23 Gloucester Crescent

Heritage Impact Assessment of Proposed Amendments to 2021/2518/L

November 2021

This supporting statement forms part of a Listed Building Application seeking minor amendments to approval ref. 2021/2518/L (dated 06.08.2021) and is accompanied by the following documents:

Fig. 4 York stone flags in the corridor with slates extending to meet them from the WC

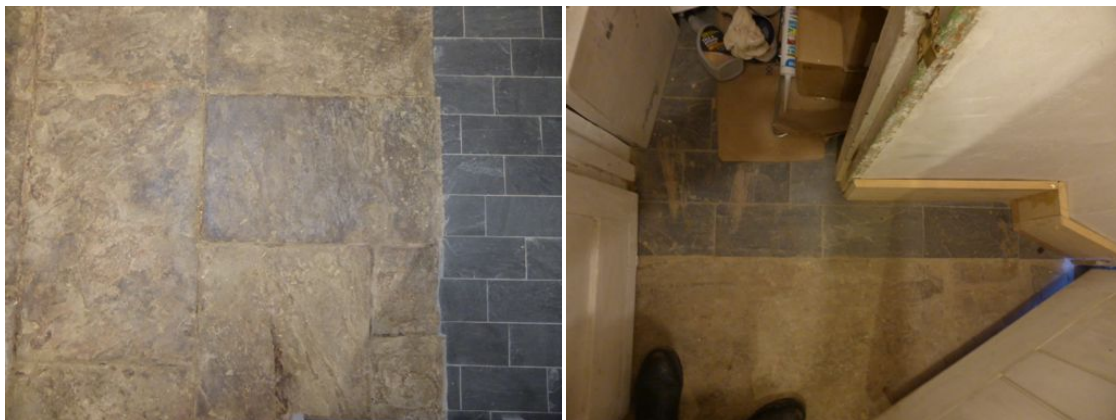
The flooring layout submitted and approved in the previous amendments was drawn prior to a full clean of the York flagstones. Following the cleaning it was discovered that a small section on the WC threshold and Vault threshold were concrete and not flags, so the extent of the slate tiling extended to accommodate this (Fig.4). Drawing GC 321C documents the minor alteration in the tiling design as built.

Fig. 4 also shows the plastered wall/WC doorframe junction that, together with the Vault door was without an architrave. The re-plastering of the walls following removal of impermeable gypsum plaster requires the junctions to be dealt with. As service rooms the use of mouldings elsewhere in the house would be inappropriate as the joinery was pared down, evidenced by the basement stair and understair doorframe. With no precedent to follow, a simple thin softwood section detailed in drawing GC 302C detail E covers the frame/plaster junction. A crude cut-out to the Vault door made when a gas boiler was installed in 1969 is retained for enhanced airflow, timber slats create a grill as the original grille was missing.

Fig. 8 shattered 'Vitrolite'.

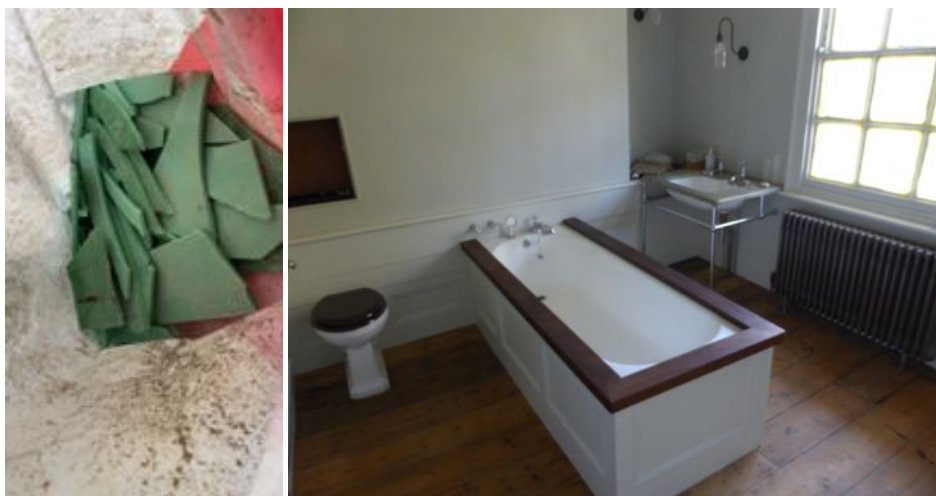
The breakage of the 'Vitrolite' glass splashback to the basin by the contractor was regrettable, it was shattered beyond repair. As this material in any colour is unavailable, a craft-made cast glass was sourced. A neutral grey-white was a suitable match for the basin marble given the inability to match the 'Vitrolite' – ref drawing GC 312B.

The bracket wall light above the basin was considered unsafe by the Electrician, with no earth lug and an inability to re-fix the bulb holder to the bracket. A suitably IP rated bracket wall light was sourced to replace the 1969 fitting, which will be retained in the house in the bathroom storage cupboard (drawing GC 304C).
